J&M Andrews Farm, Administrative Subdivision Plan No. 620190110

Recommendation – Approval with conditions

Summary

Figure 3 – Administrative Subdivision Plan (Simplified)

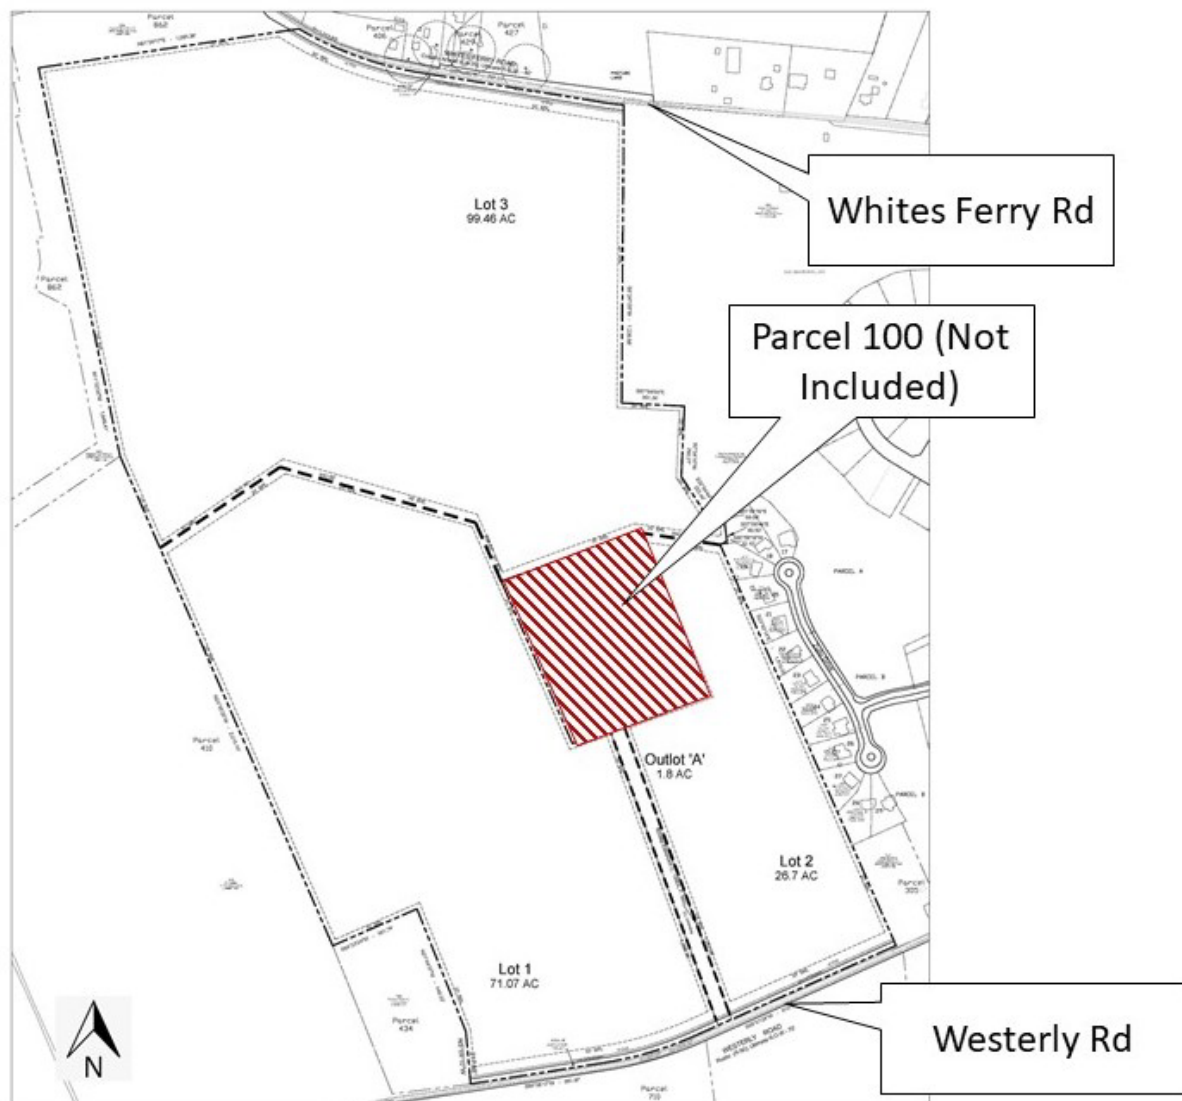
3. The Applicant must submit a revised administrative subdivision plan indicating "Outlot A" as a unplatted remainder not an outlot.
4. The Applicant must dedicate and show on the record plat(s) the dedication of 35 feet of right-of-way from the existing pavement centerline along the Subject Property frontage for Westerly Road and 40 feet of right-of-way from the existing pavement centerline along the Subject Property frontage for Whites Ferry Road.

WSSC GRID 224NW20
TAX MAP CT122
M-NCPIC FILE NO. 620190110
SHEET 1 OF 5

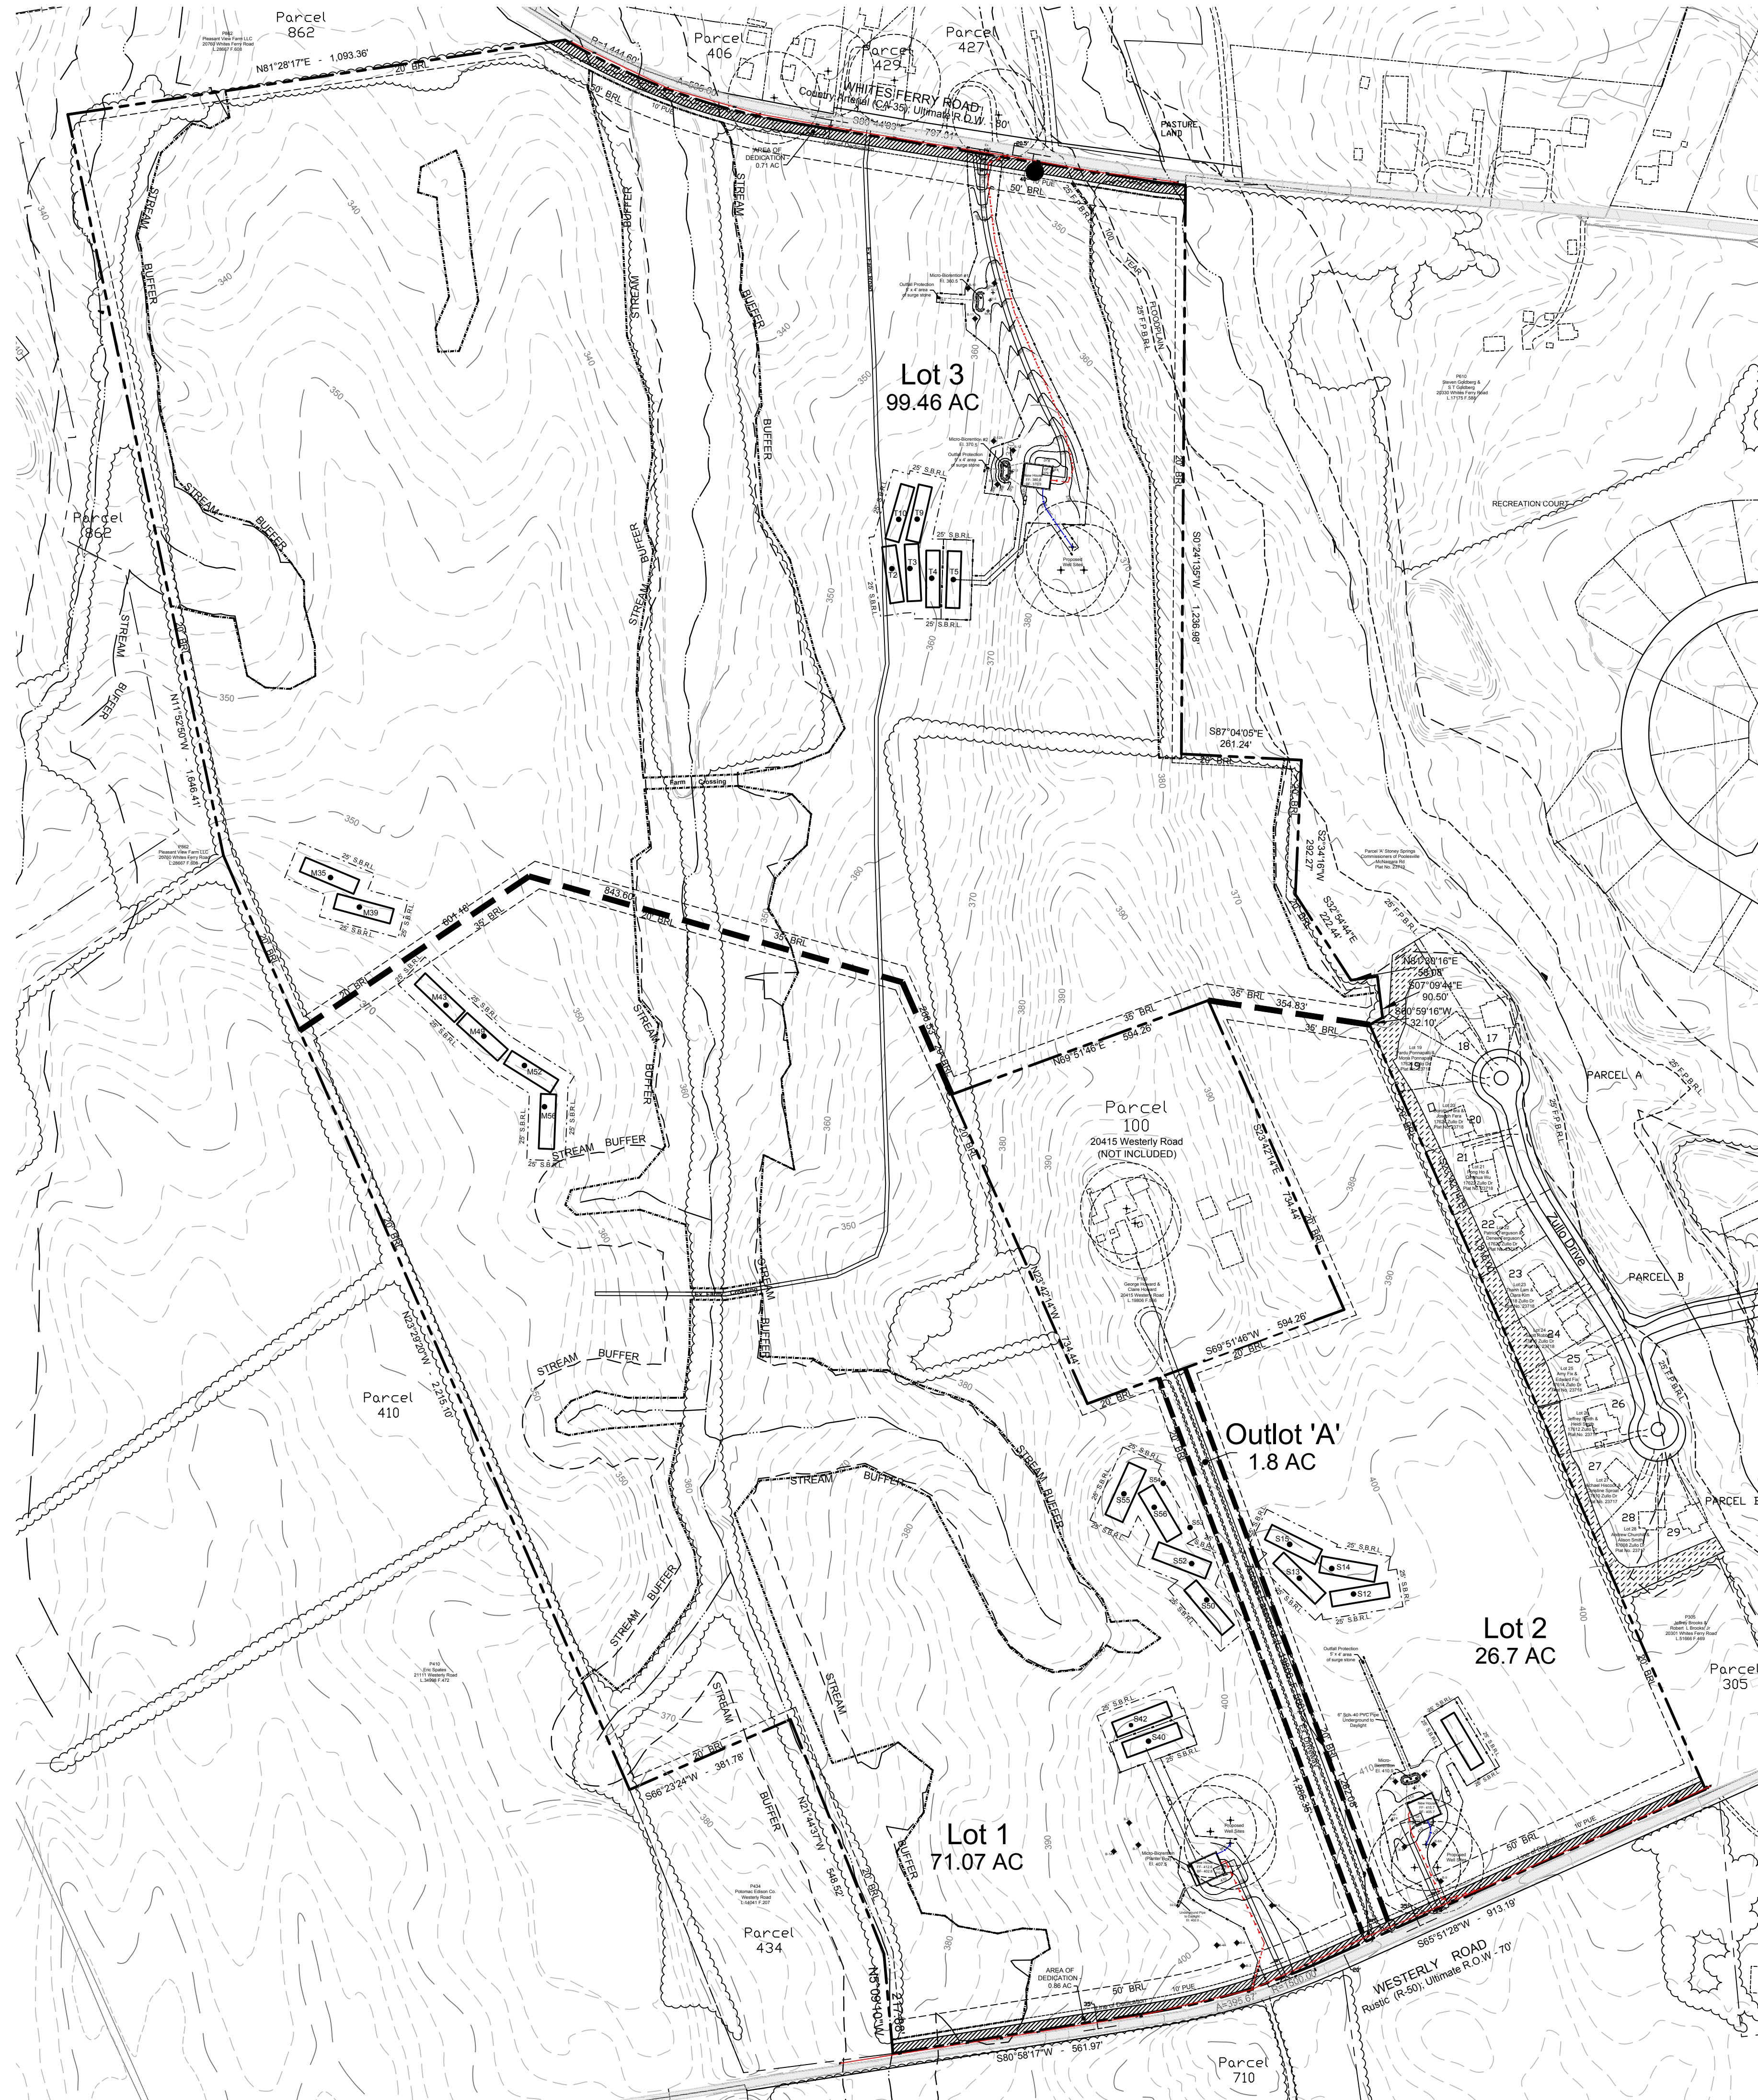
- a. Whites Ferry Road (MD-107): We defer to MDSHA for sight distance acceptance.
- b. Westerly Road: Based on the sight distance uploaded to eplans dated June 24, 2019, we **have not** approved the sight distance and have the following comments:
 - i. Clarify if the utility pole in the vicinity of Lot 1 is blocking the line of sight distance. If the line of sight is limited by the existing utility pole, the applicant

Based upon the acreage (198.7 A), the plan indicates that 7 lots could be permitted (25-acre zoning). The development plan indicates 3 lots “shown.” Are we to assume that this is phase 1 and that 4 more lots will be added in phase 2? Will there be a legal restriction on any further development of the land beyond the current 3 lots? If not then the plan needs to provide facilities for complete development of the land.

There are a bunch of small rectangles on the plan, each with an “M#”, “S#” or “T#” located in them. The legend gives no indication of rectangles with “M, S, or T#” in them. We think that these are sand mounds for septic treatment and indeed, some are connected to the houses with a symbol identified in the legend as “Septic Tank”. We assume that these lines are not really tanks, but pipelines. The rectangle on Lot 2 has no identification
